WINCHESTER SOUTH PROJECT

Response to Submissions

Surface Water and Flooding Responses

Whitehaven Coal Limited
0869-10-A1, 22 March 2023

Figure 2.1 - Waterway mapping and watercourse classification

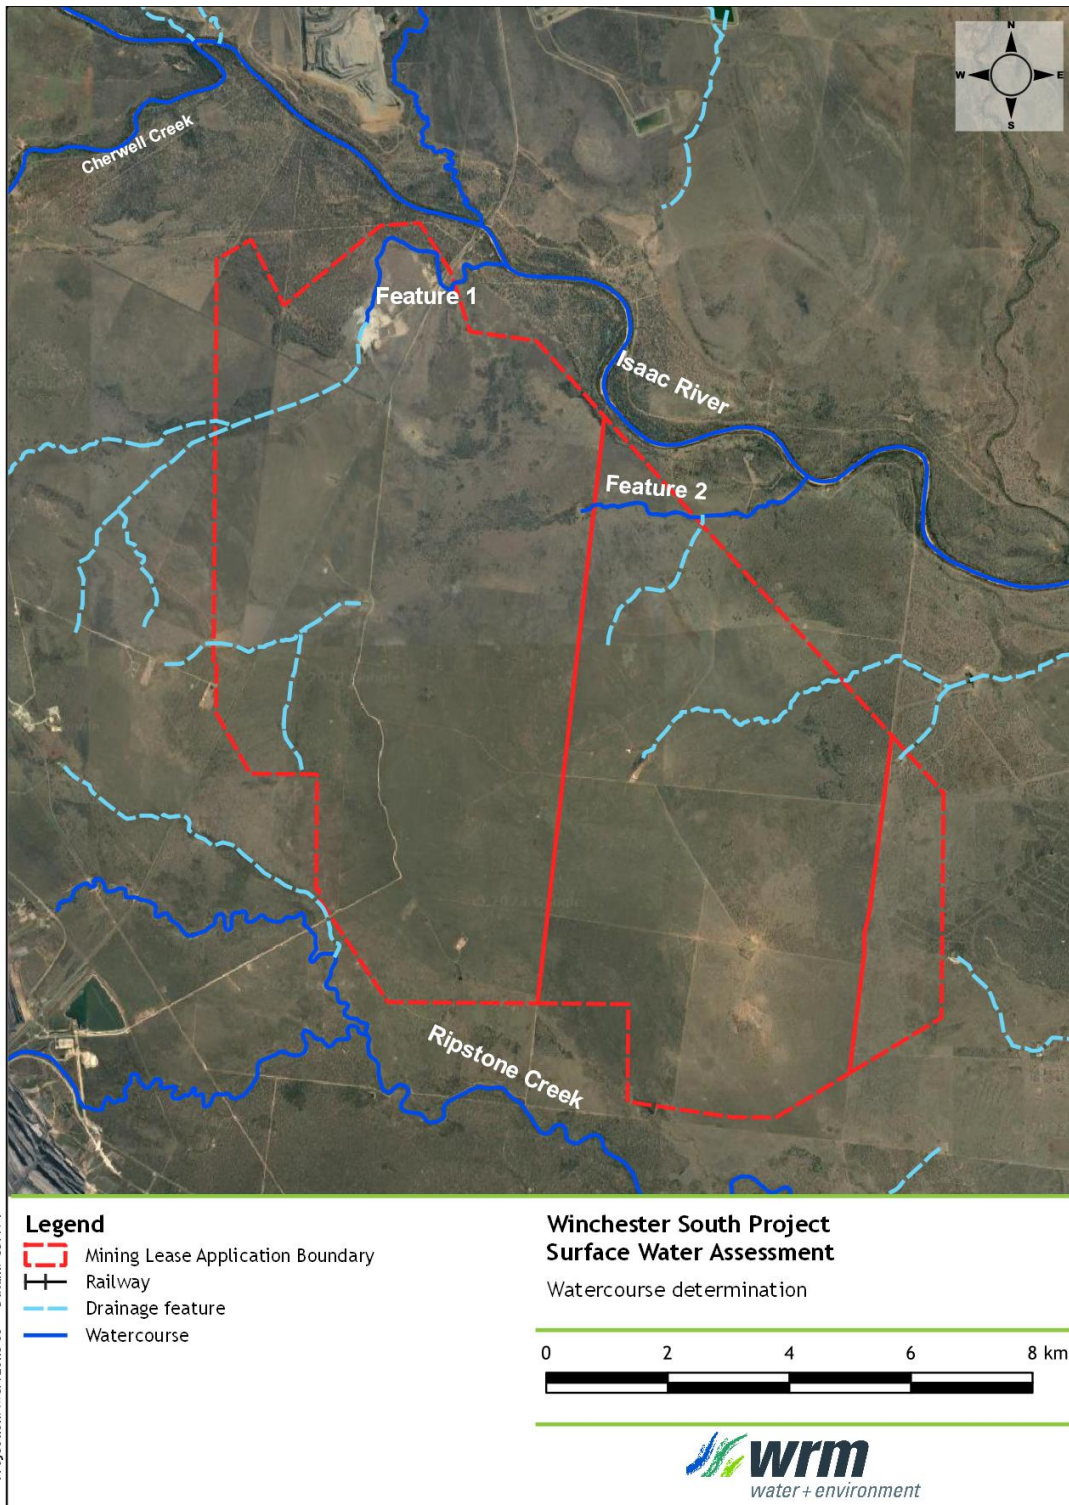
Clarify what order are the waterways/creeks that exist within the surface area; if any waterways/creeks are proposed to be diverted or if diversions are not occurring, what is happening with existing waterways/creeks within the surface area.

Watercourse classification of all drainage lines that intersect the Project is provided in Section 4.2.4 of the SWFA (WRM, 2022) (reproduced in Figure 2.1 below) and are consistent with the *Watercourse Identification Map (WIM)* classifications under the Water Act 2000 published by the Department of Regional Development, Manufacturing and Water (2023).

The maximum Project disturbance has been overlaid onto the waterways in Figure 2.1, and shows the following:

Figure 2.2 - Residual void catchment plan

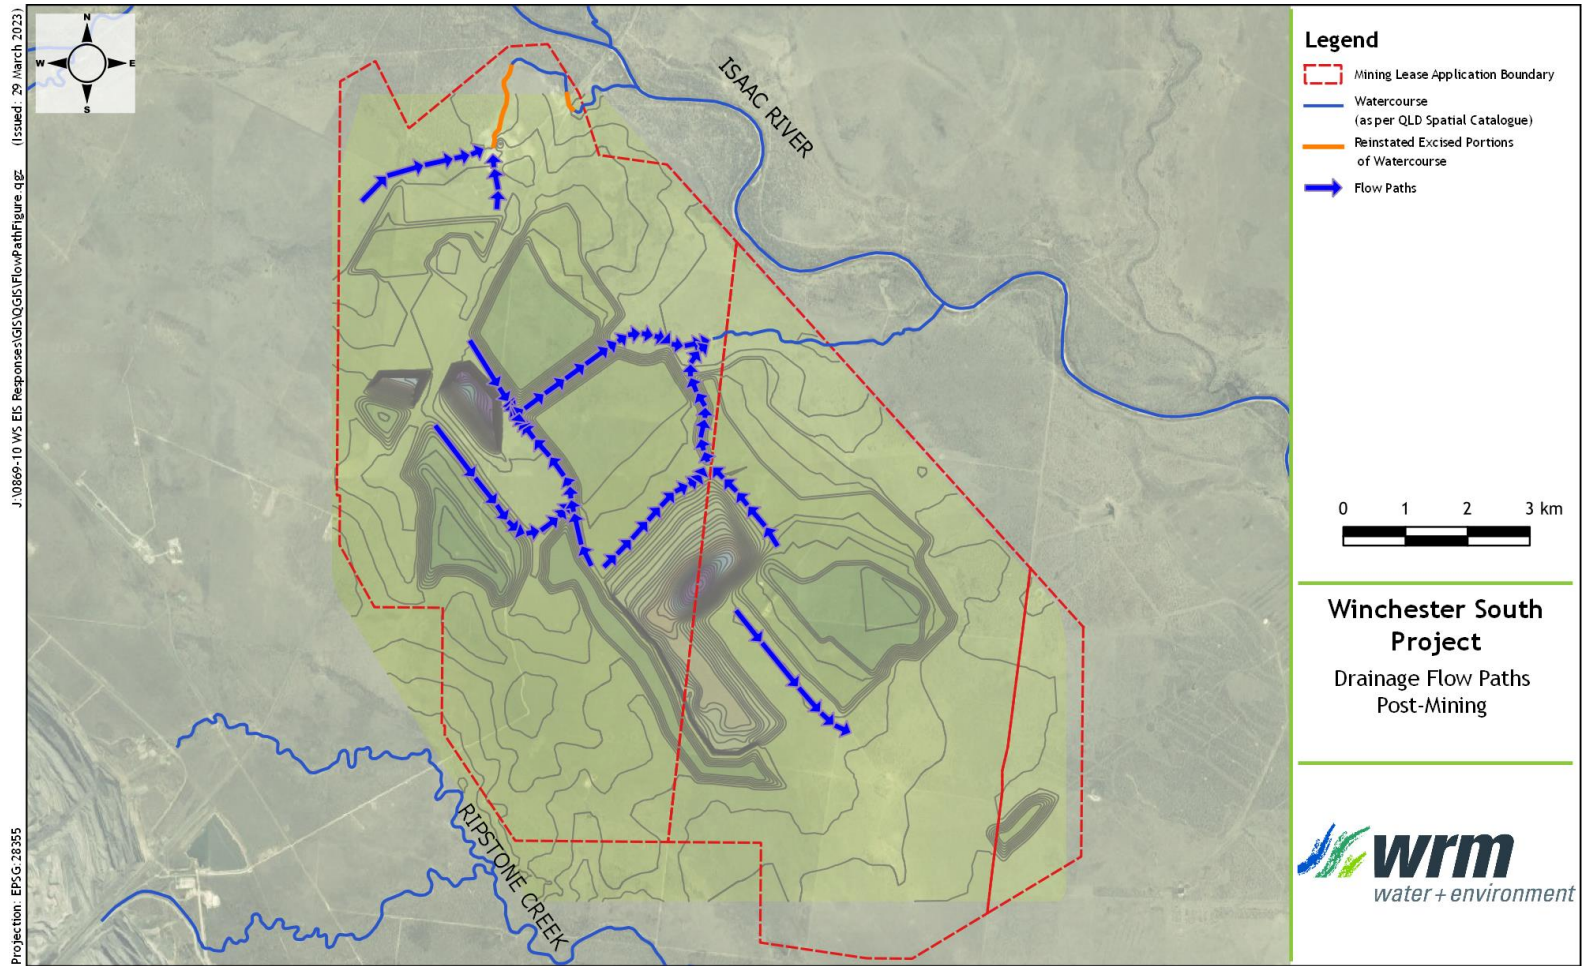
Clarify the relationship of clean water diversions with the reinstated waterway and indicative surface water drain shown on Figure 7-1d of the Additional information document and discuss changes to water flow paths/patterns (e.g., temporary/permanent diversions or interception of overland flow and interference/disturbance of watercourses and floodplain areas). Also see comments in Issue number 480.89 on changes to water flow paths/patterns.

The proposed drainage configuration for the final landform is provided in Section 8 of the SWFA (WRM, 2022) (reproduced in Figure 2.1 below). Figure 2.2 shows that:

- The majority of the Drainage Feature 1 catchment will be reinstated to drain back to the Isaac River.
- The Drainage Feature 2 catchment will be reinstated to drain back to the Isaac River.

Figure 2.4 - Watercourses and drainage flow paths - Pre-mining

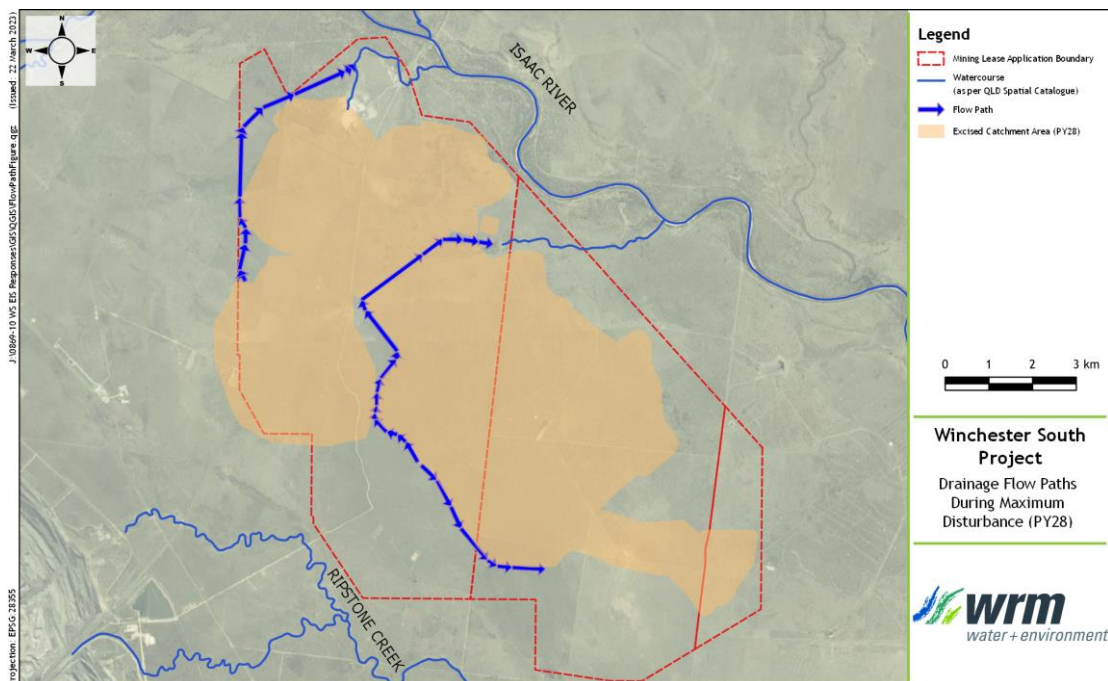
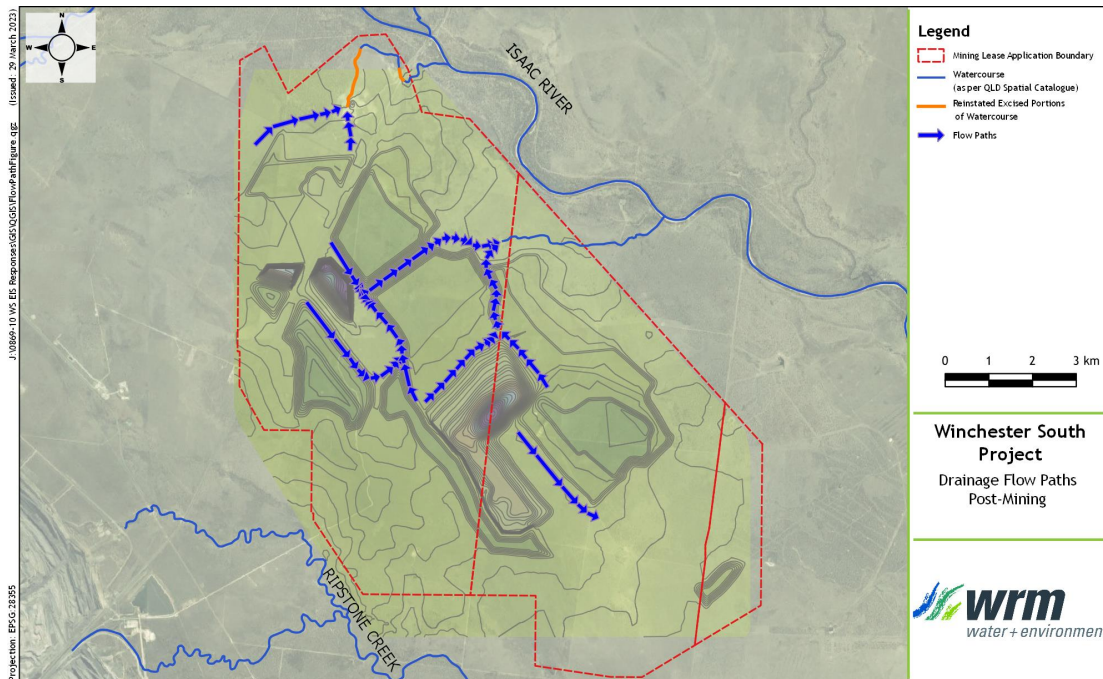
No details were provided in the RDEIS on changes to water flow paths/patterns such as temporary/permanent diversions or interception of overland flow, interference/disturbance of watercourses and floodplain areas, including maps of suitable scale showing the locations. See comments on Issue number 480.32 on diverting waterways/creeks, clean water clean water diversions, reinstated waterway and indicative surface water drain. Provide a revised list of proposed EA conditions with details on permanent and temporary disturbance of water flow paths/patterns, including diversion, interception of overland flow and interference/disturbance of watercourses and floodplain areas and include maps at suitable scale of all locations. Also link disturbance of water flow paths/patterns with clean water clean water diversions, reinstated waterway and indicative surface water drain.

The defined flow paths and watercourses during for the pre-mining, operational (maximum disturbance) and post-mining phases are presented in Figure 2.4, Figure 2.5 and Figure 2.6.

Figure 2.7 - Residual void water level- North-west Void

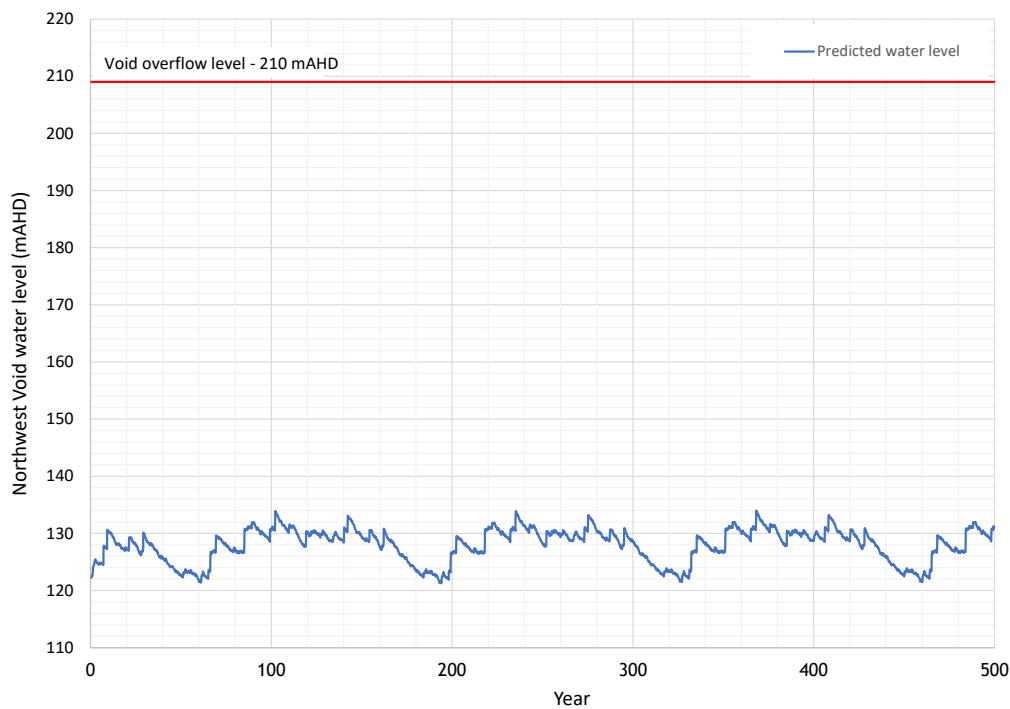
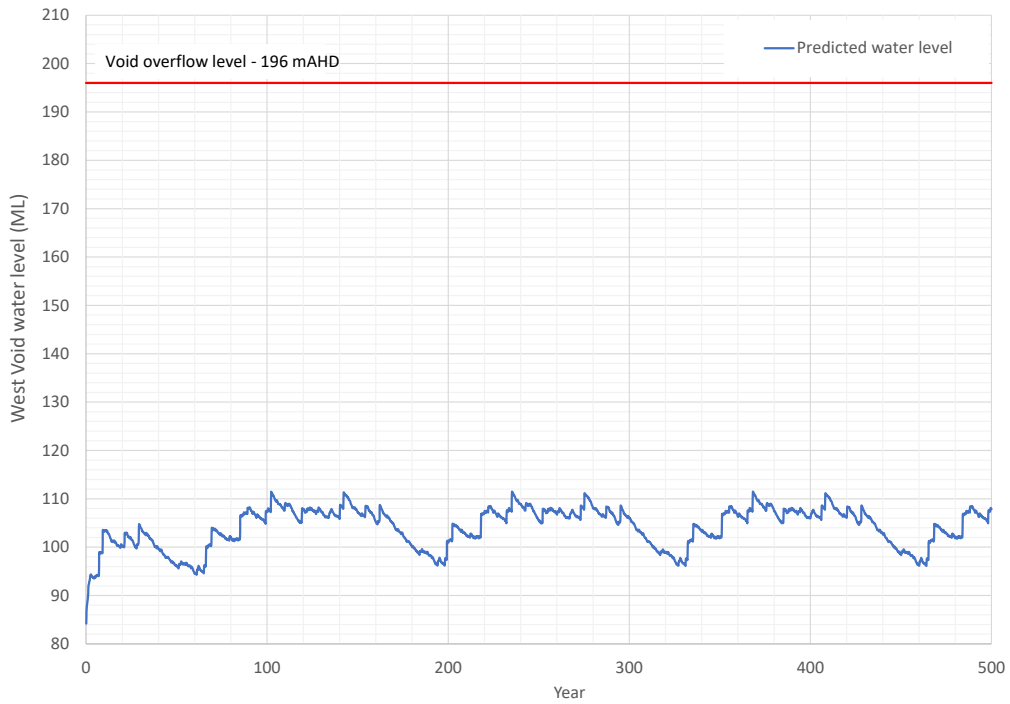
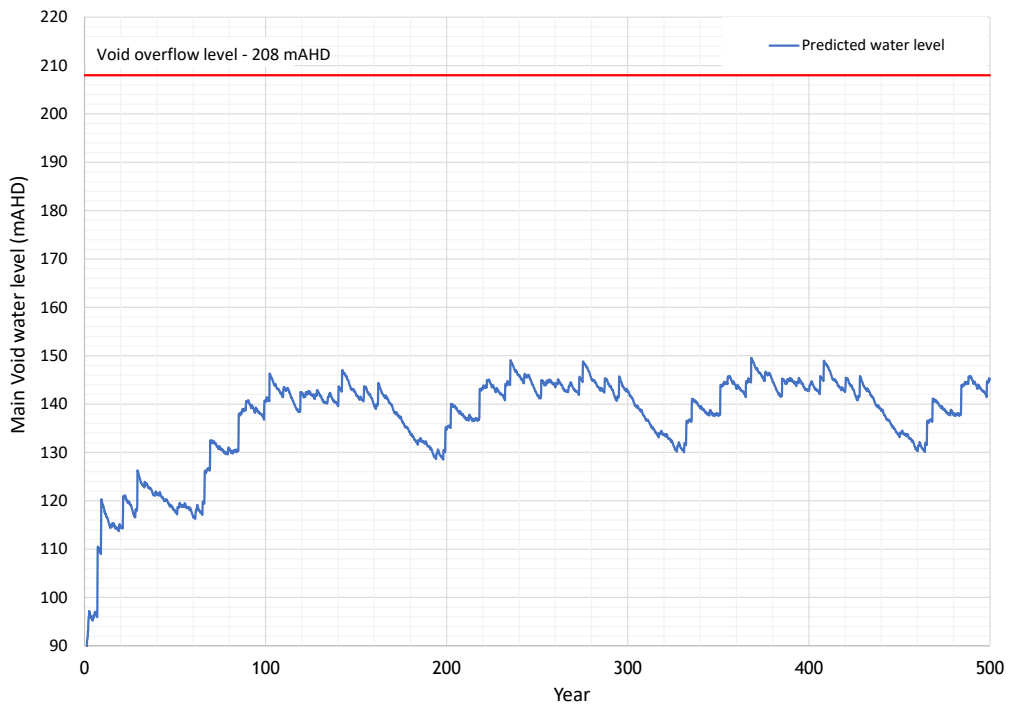
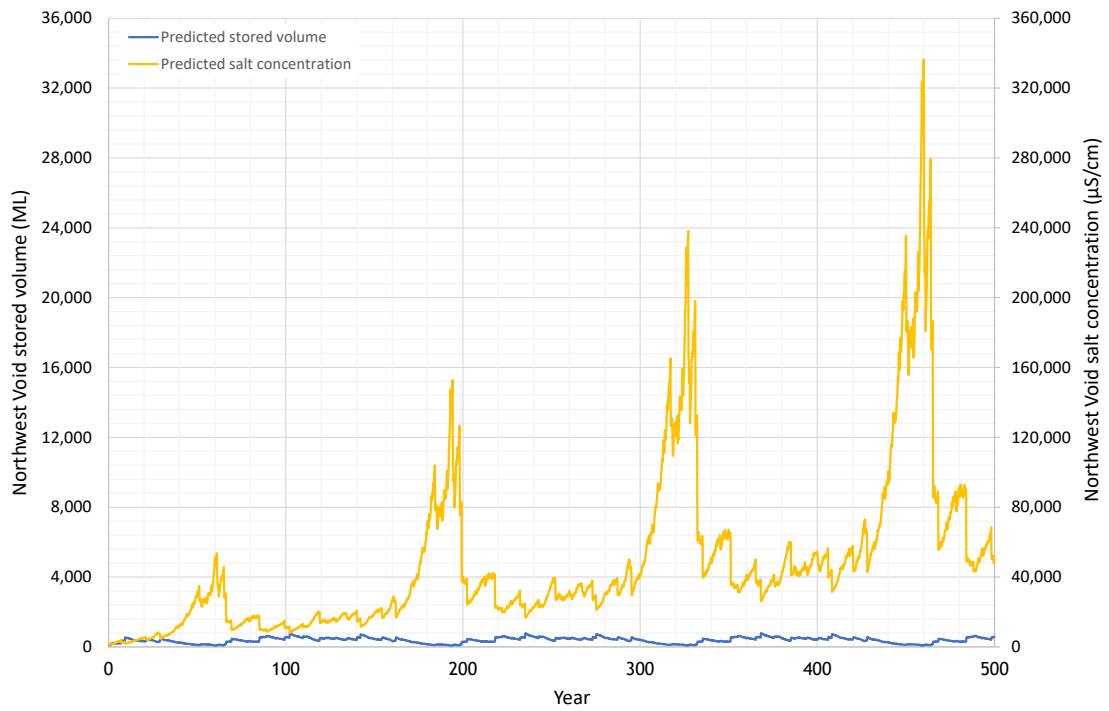
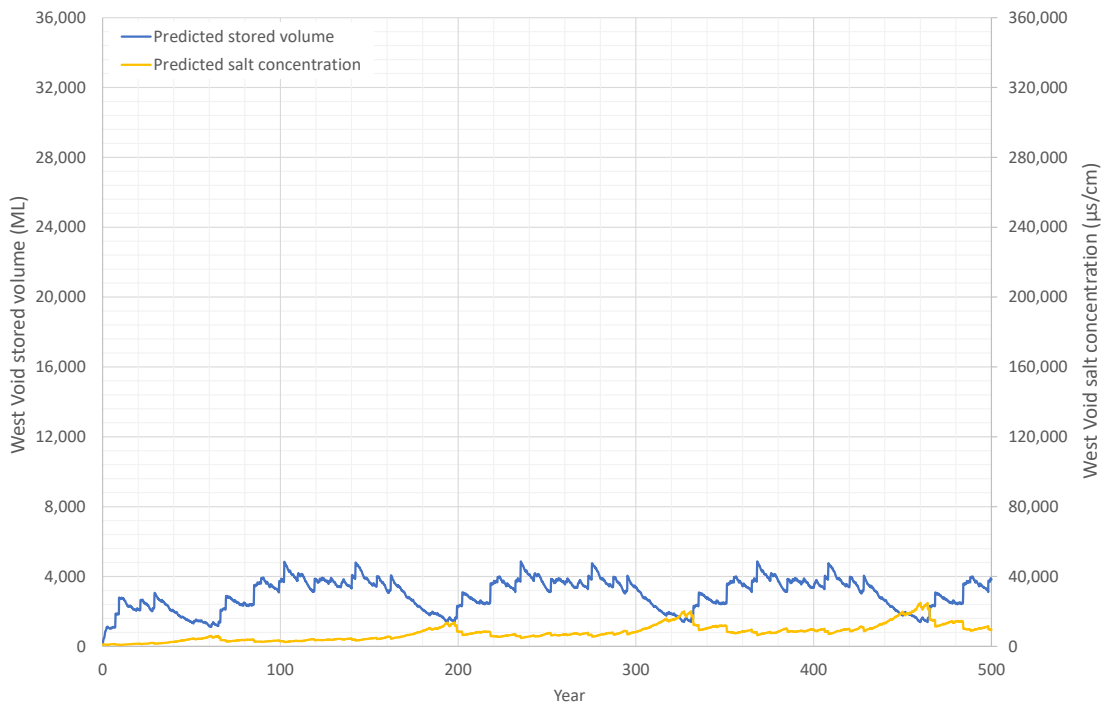
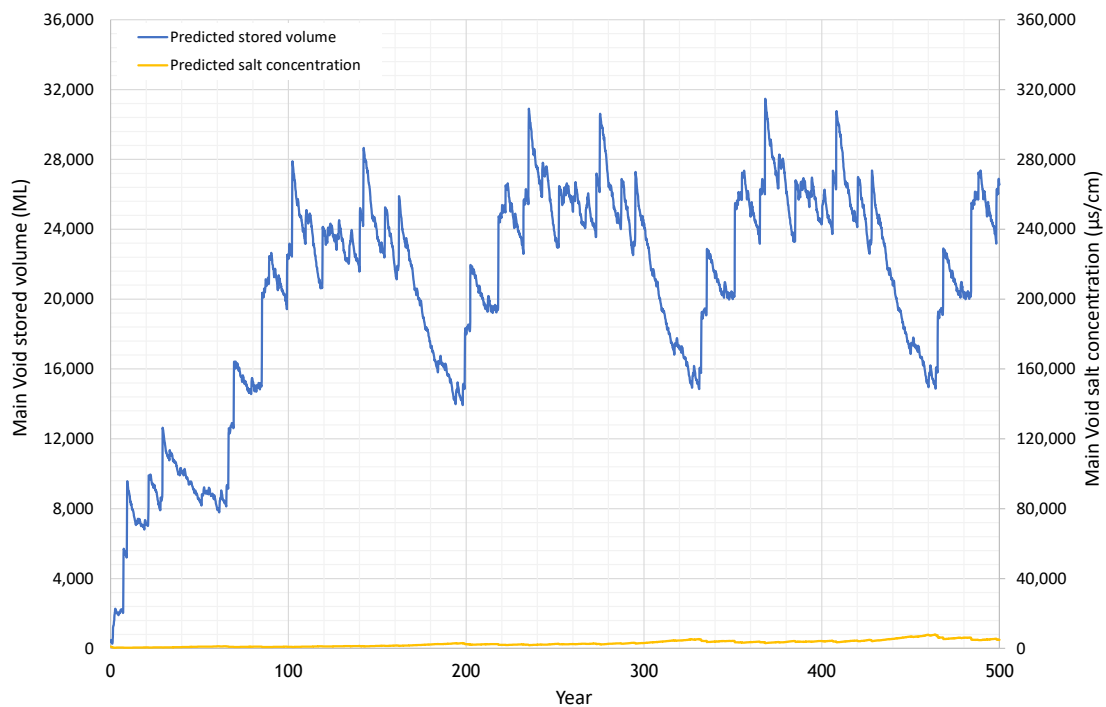
The proponent to provide evidence that each residual void is suitable to be repurposed as water storage for agricultural production to supply drinking water to cattle over both the short- and long-term. Clarify the statement in Table 7-1 on the suitability of the water in voids as stock drinking water.

Residual void modelling without a beneficial use demand has been undertaken as per the comments from DES. The model results are presented in Figure 2.7 to Figure 2.12.

The results show that even without a beneficial use demand applied, Main Void would still be more than capable of supplying stock water over the 500 years of simulation. At equilibrium, the majority of the water stored within the residual voids is located within Main Void (around 87%), with around 12% stored within West Void and around 1% stored within North-west Void. Although North-west Void and West Void have elevated salinity, this could be managed by diluting with Main Void water, noting that:

- the North-west Void and West Void are comparatively small relative to Main Void and contain a very small proportion of the total water stored within the three voids; and
- periods of elevated salinity coincide with dry periods (i.e. when smaller volumes of water are stored in the North-west Void and West Void).
